Access Compliance Report

Public Rights-of-Way

Intersection ID: 10337	Main Street: E_36TH_ST	Cross Street: SPENCER_ST	Location: E
ADA ID: 58416EA6B2C4	Ramp Type: PerpDiag	Initial Pass/Fail: Fail	Overall Compliance: No
		Severity Score: 8.75

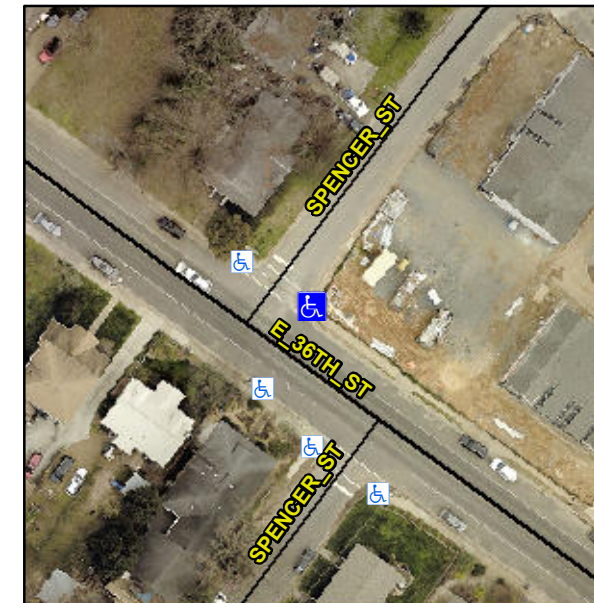
Not Found, R304.5.1

Compliance	Description	Data	Compliance	Description	Data
N/A	Ramp Length (in)	60.0	Yes	Ramp Slope (%)	7.6
No	Ramp Width (in)	47.5	Yes	Ramp XSlope (%)	0.6
N/A	Flare Type LT	N/A	N/A	Flare Type RT	N/A
N/A	Flare Slope LT (%)	N/A	N/A	Flare Slope RT (%)	N/A
N/A	Flare Traversable LT?	N/A	N/A	Flare Traversable RT?	N/A
N/A	Landing Length (in)	N/A	N/A	DWS Provided?	N/A
N/A	Landing Width (in)	N/A	N/A	DWS Contrast?	N/A
N/A	Landing Slope (%)	N/A	N/A	DWS Length (in)	N/A
N/A	Landing X Slope (%)	N/A	N/A	DWS Full Width?	N/A
N/A	Landing Curb? (Y/N)	N/A	N/A	DWS Offset (in)	N/A
N/A	Shared Landing?	N/A			
N/A	Gutter Ponding?	N/A	N/A	Gutter Slope (%)	N/A
N/A	Gutter Lip Ht (in)	N/A	N/A	Gutter X Slope (%)	N/A
N/A	Painted X Walk1?	Yes	N/A	Painted X Walk2?	No
	X Walk 1 Direction	To NW		X Walk 2 Direction	To SW
N/A	X Walk 1 Width (in)	113.0	N/A	X Walk 2 Width (in)	N/A
	X Walk 1 Slope (%)	1.4		X Walk 2 Slope (%)	1.8
	X Walk 1 X Slope (%)	0.0		X Walk 2 X Slope (%)	0.0

Remove & Replace Curb Ramp With Two New Directional Ramps or Equivalent.
